Keithley Instruments  
28775 Aurora Road  
Cleveland, Ohio 44139  
1-800-833-9200  
[tek.com/keithley](http://tek.com/keithley)

This firmware is used on the following Keithley Instruments product models:

- Model 2461 High-Current SourceMeter® Instrument
- 2461-NFP
- 2461-RACK
- 2461-NFP-RACK

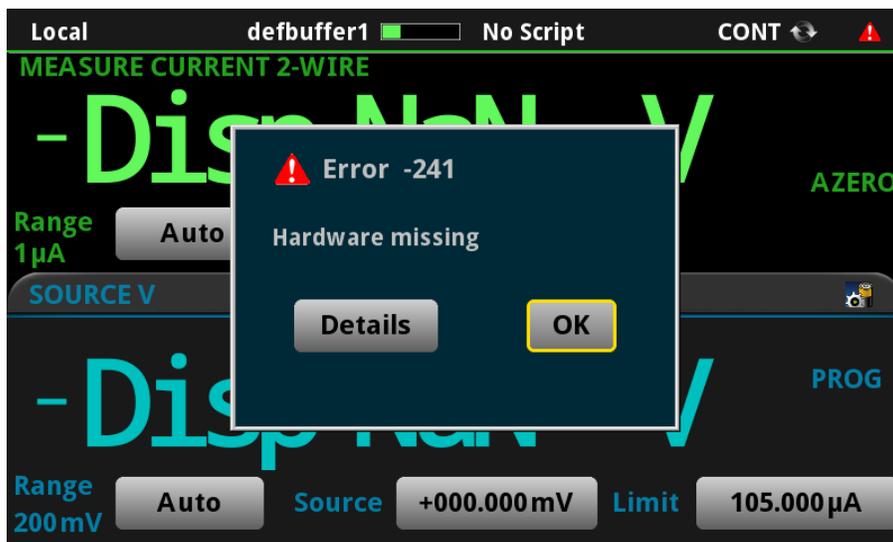
PR61502 From a cold power up, the Model 2461 SMU will sometimes fail with the following error message and will not operate properly.

If this issue occurs, a subsequent power cycle will allow the instrument to power up properly.

This issue has been corrected with firmware revision v.1.6.5.
